### FLORIDA STATE UNIVERSITY – JOHNSTON BUILDING

Issue: Vertical accessibility to all rows of seating in a classroom.

# REQUEST FOR WAIVER FROM ACCESSIBILITY REQUIREMENTS OF CHAPTER 553, PART V, FLORIDA STATUTES

Name: Florida State University - Johnston Building (FS-248) Remodeling and Expansion

## REVIEW AND RECOMMENDATION BY LOCAL BUILDING DEPARTMENT.

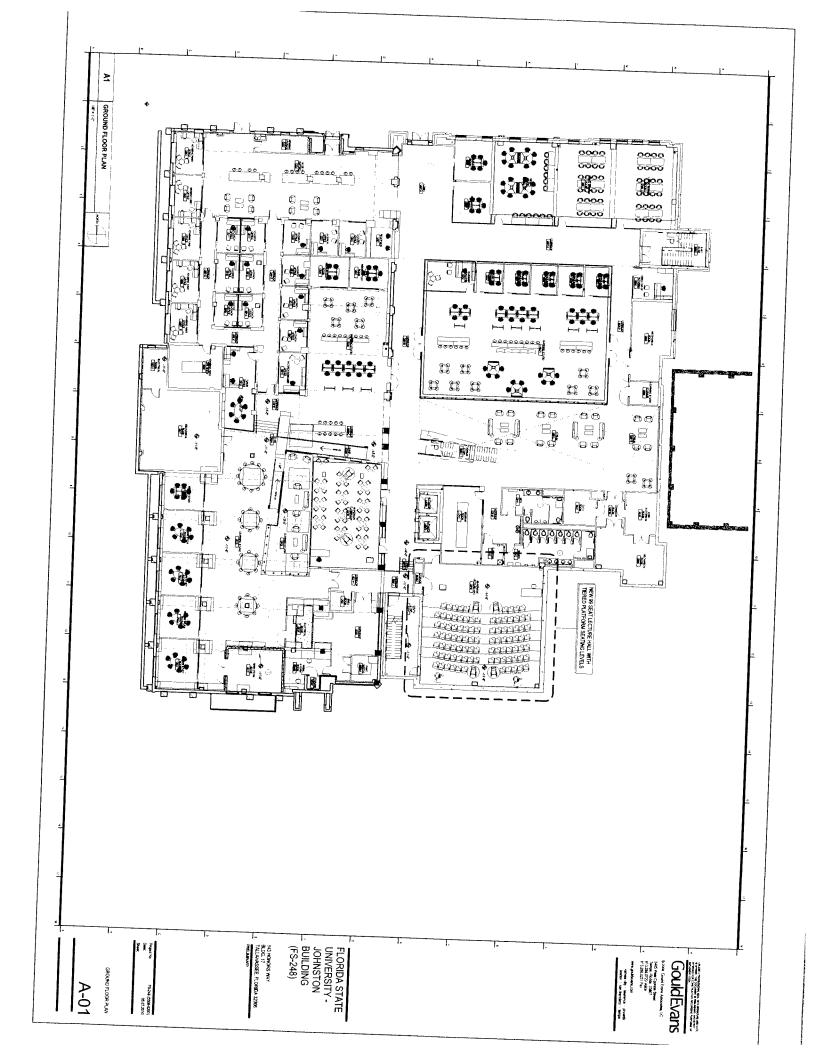
The recessionity Code.
a. 99 person lecture hall per FS 533.509 with tiered, fixed seating does not provide for accessible seating at each level. Distribution of handicapped seating is provided at multiple locations in
D
Ias there been any permitted construction activity on this building during the past three years? If o, what was the cost of construction?
X ] Yes [ ] No Cost of Construction: Current contract is for +- \$34,000,000
omments/Recommendation: Approve Request 9
risdiction: Florida State University Fuilding Code Administration
ailding Official or Designee
Signature
Tom C. Deckert, CBO
Certification Number: (FL) BU 1157
(000)
